ITS3 JIG manufacturing

Manufacturing ongoing

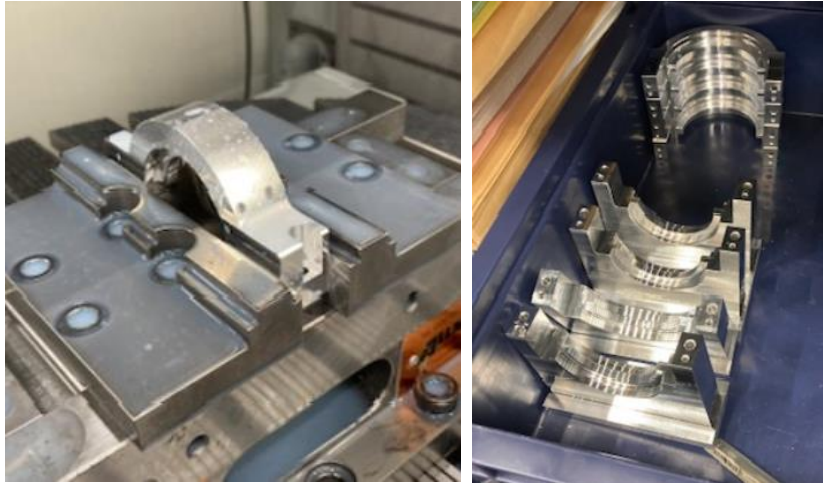
---Lead time on 7075 , we hope a couple weeks

---Changed 6082 long parts with mill operations to
Cast aluminium for straightness (5000CTP/tooling plate)

Requested delivery time ?

Should we anodize ?

Pro---scratch resistant and “micro deburring” because of etching
contra---theoretical isolating could be static charge problem

If we want to test now would probably be best to gain experience
